VARIANCE REQUEST
Iowa Department of Natural Resources

1. Date: October 15, 2002	13. Decision: <u>Approved</u>
2. Review Engineer: Larry Bryant	Date: <u>10/22/02</u>
3. Date Received: August 6, 2002	
4. Facility Name: City of Eagle Grove	14. Appeal:
5. County Number: 99 (Wright)	Date:
6. Program Area: CP (Wastewater Construction)	
7. Facility Type: C05 (Biological Treatment)	
8. Subject Area: 321 (Reliability)	
9. Rule Reference: 567-64.2(9)a	
10. Design Stds Ref: 14.5.2.3.4 (Final Clarifier Duplication)	
11. Consulting Engr: Kuehl & Payer Ltd.	
12. Variance Rule: 567-64.2(9)c

RE: Variance Request
Eagle Grove WWTP - Phase I Improvements

Jan 87-Aug 02 Effluent TSS
vs. Final Clarifier Loading

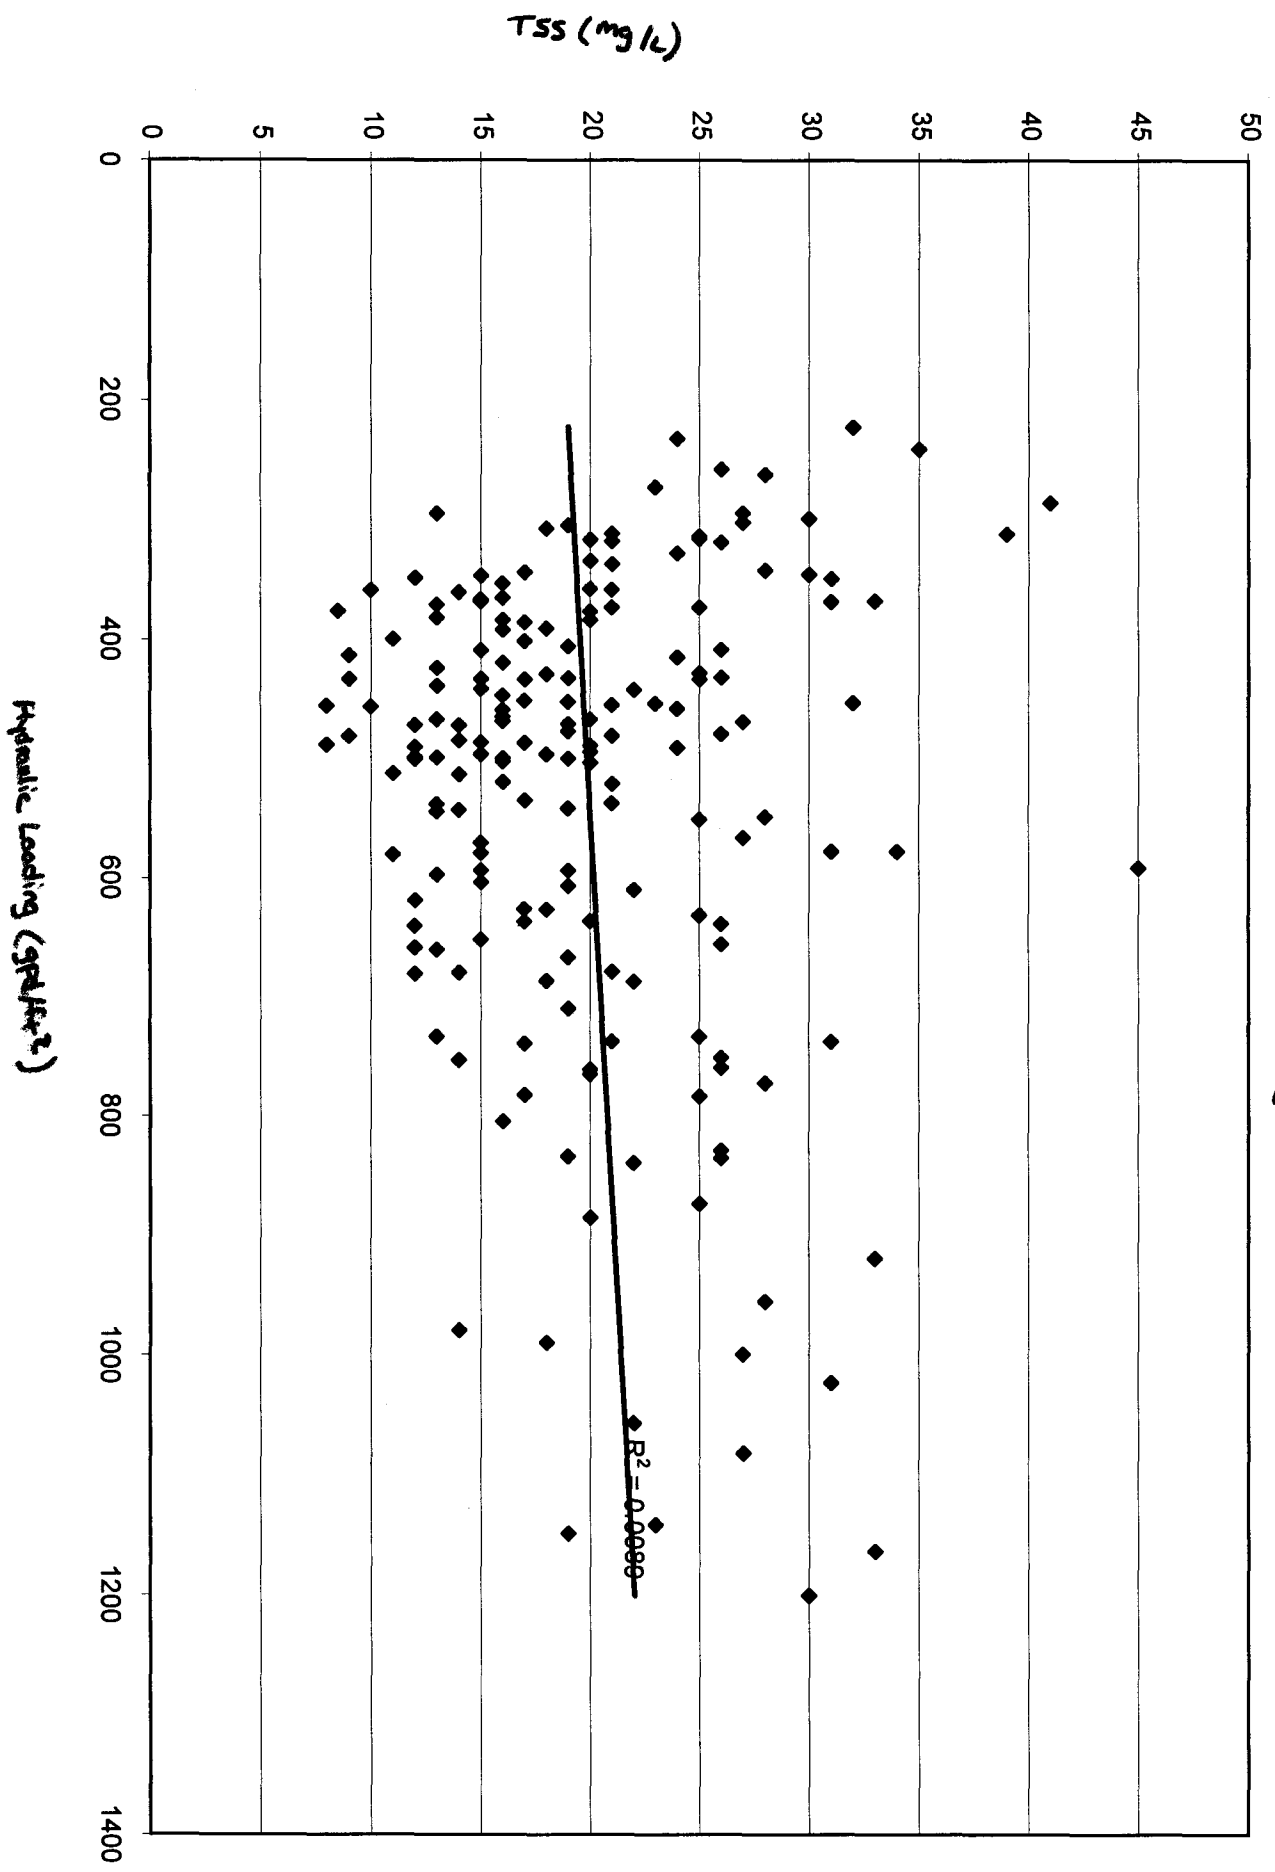
I have plotted 30-day values for clarifier loading vs. effluent TSS for data since January 1987. The existing final clarifiers have at times approached or exceeded the maximum peak hourly loading rate of 1,200 gpd/sq. ft. allowed by the Design Standards for 30 days or more and 15 average effluent TSS violations have occurred during the 186-month time period analyzed. However, no good correlation between the clarifier loading rate and effluent TSS was found (see attached graph). This may indicate that previous effluent TSS violations (and high TSS values in general) for this facility are more strongly linked to inadequate sludge storage (a need for additional sludge storage has been identified and is included as part of the proposed improvements) and/or operational factors other than the final clarifier loading rate.

Based on the above, approval is recommended on the basis that the proposed configuration will provide equivalent effectiveness while significantly reducing cost.
